Agenda
Village of Arlington Heights
Design Commission
Community Room, 3rd Floor

Arlington Heights Village Hall
33 S. Arlington Heights Road
Arlington Heights, IL 60005
September 13, 2018
6:30 PM

**MINUTES OF
THE VILLAGE OF ARLINGTON HEIGHTS
DESIGN COMMISSION MEETING
HELD AT THE ARLINGTON HEIGHTS MUNICIPAL BUILDING
33 S. ARLINGTON HEIGHTS RD.
AUGUST 28, 2018**

PROPOSED SIGN

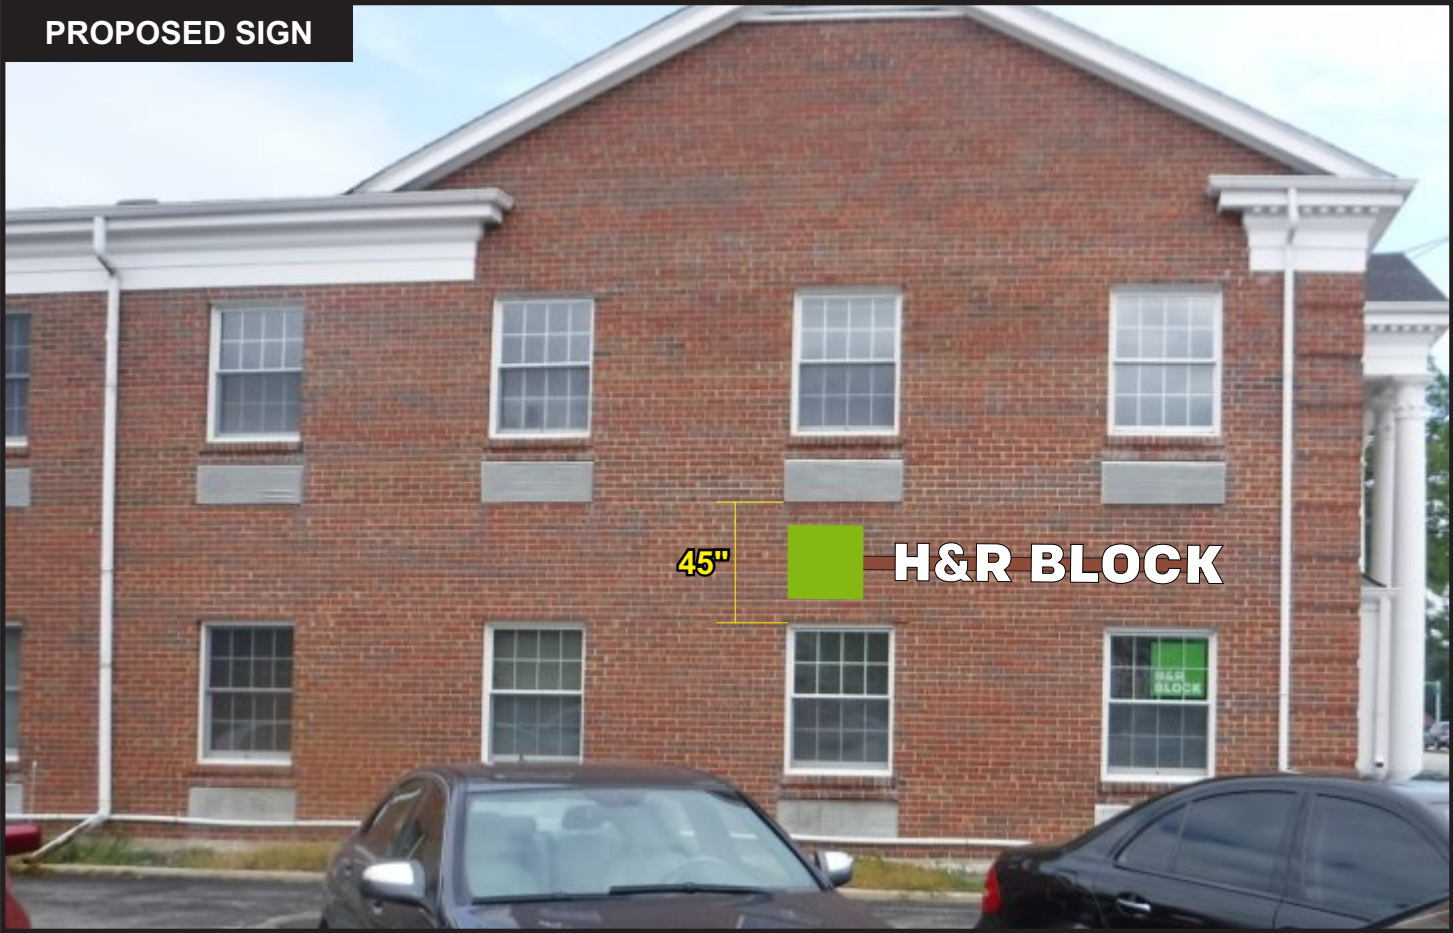
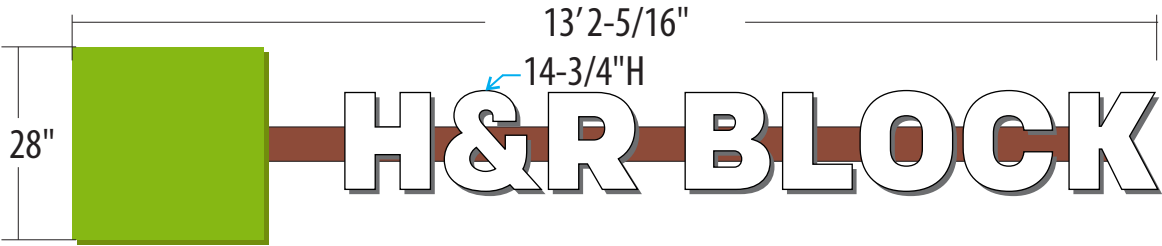
1. A variation from Chapter 30, section 30-402 Number, to allow one wall sign on the side of the building, where zero wall signs are allowed.
2. A variation from Chapter 30, section 30-403a Dimensions, to allow a 30.8 sf wall sign on the side of the building, where zero sf is allowed.

RENDERED
EXTERIOR
ELEVATIONS

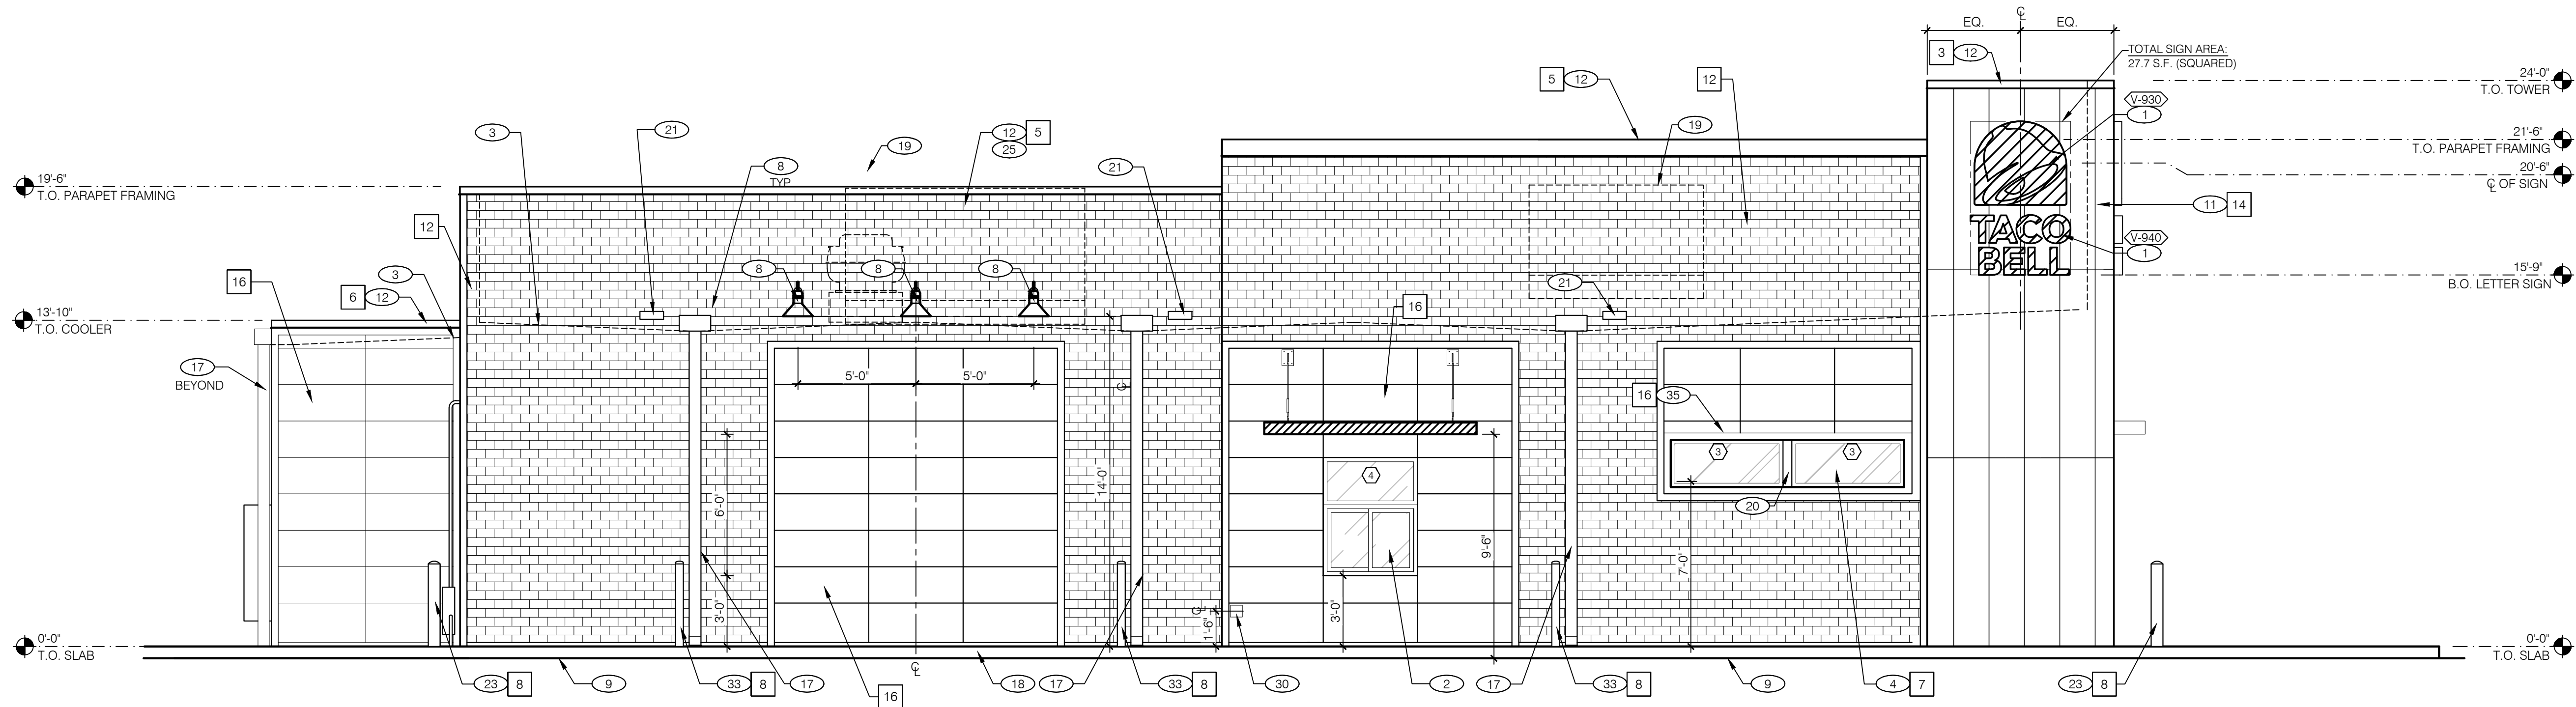
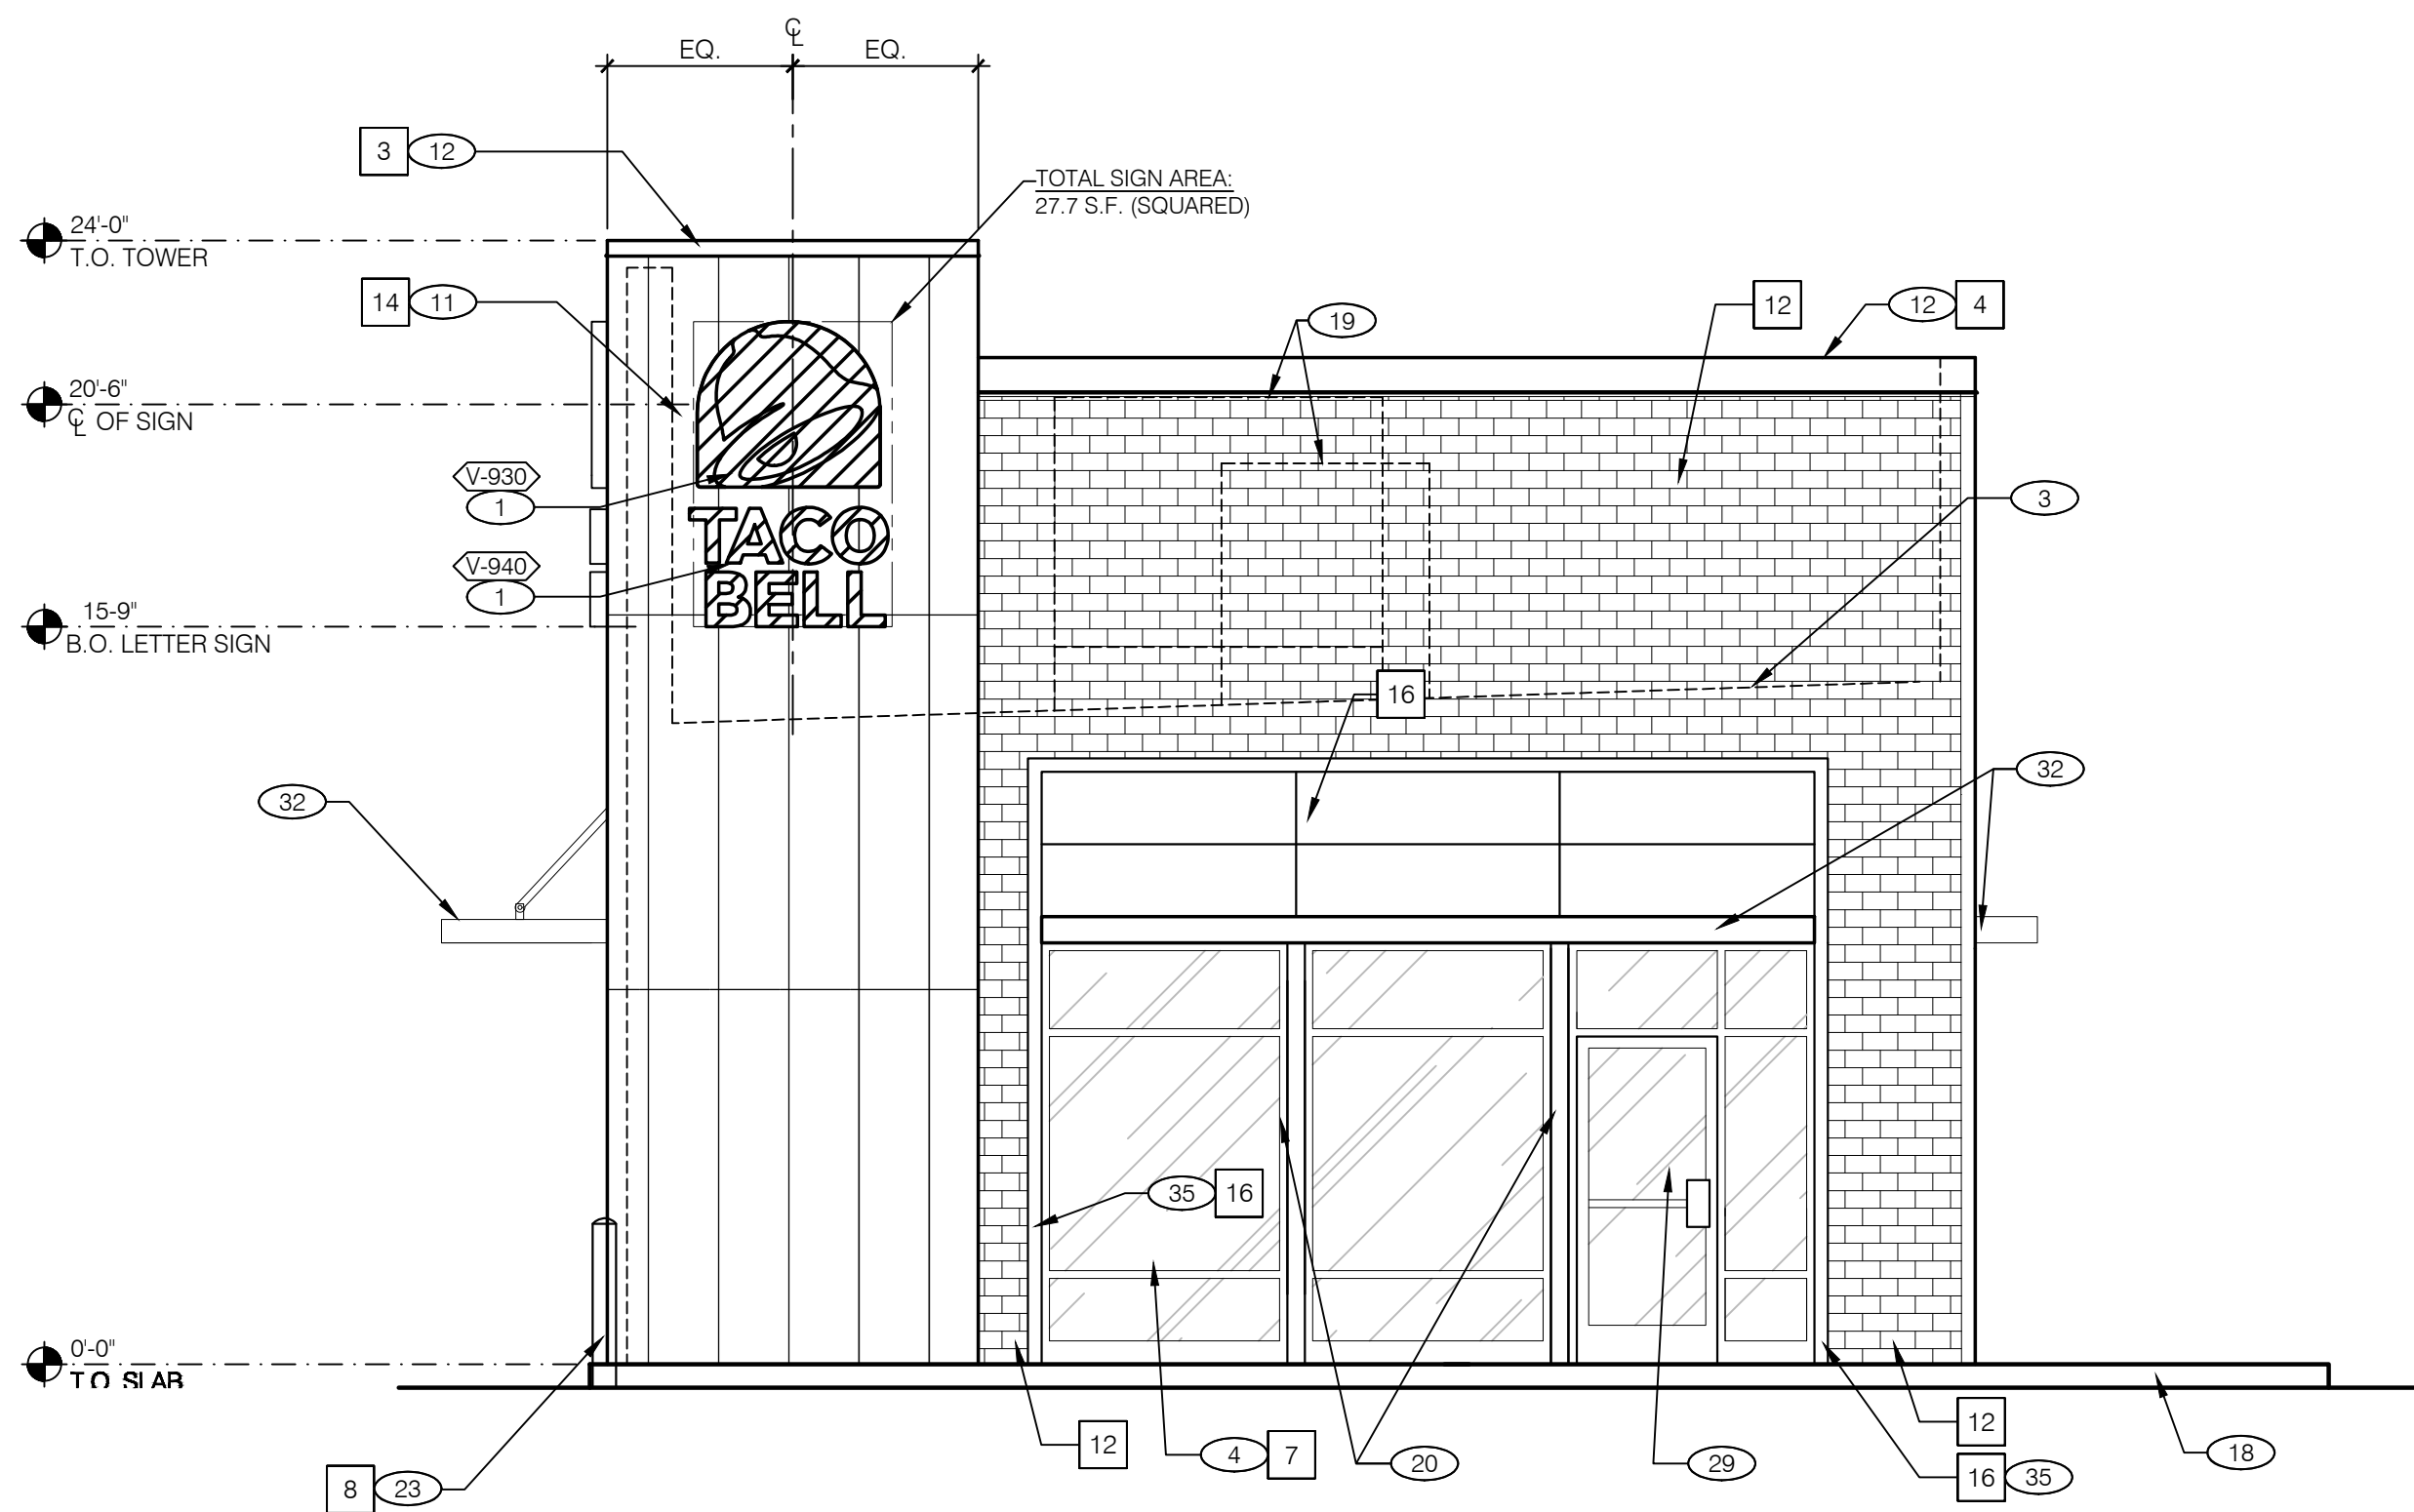
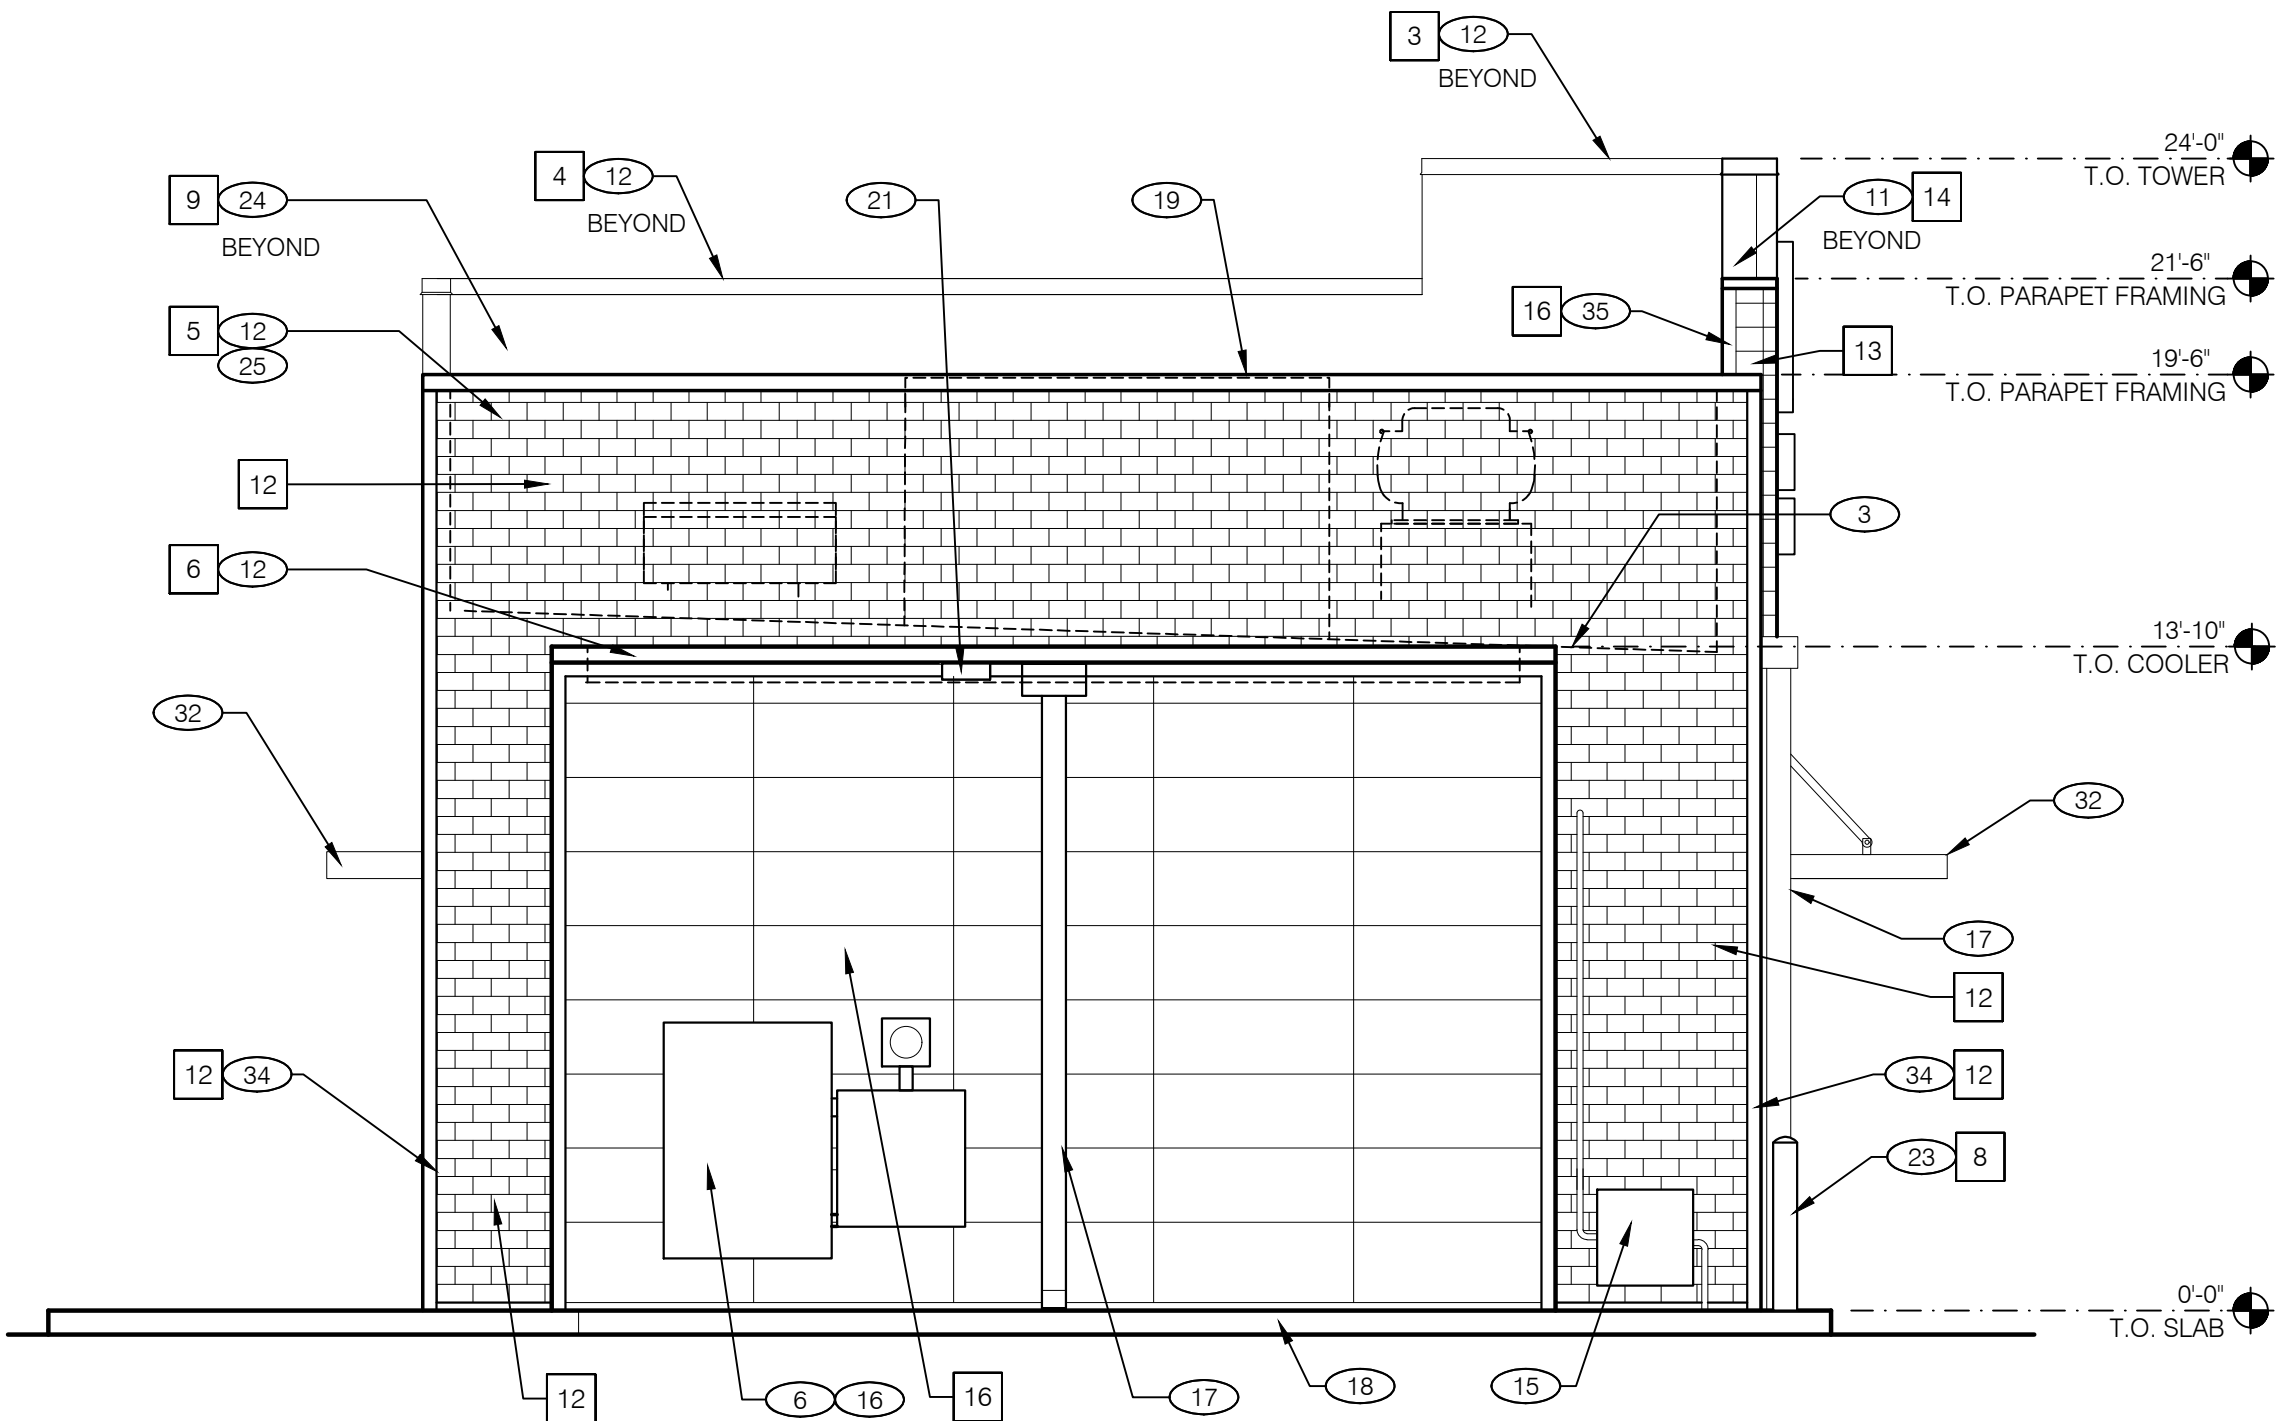
3. The maximum allowed height for a ground sign is 16'-6". The proposed 20'-0" tall ground sign needs to be reduced in height to comply with code.

1. The petitioner is required to meet the Sign code, Chapter 30 or obtain a sign variation(s).
2. It is recommended that the second wall sign on the side of the 'rustwall' tower be omitted.
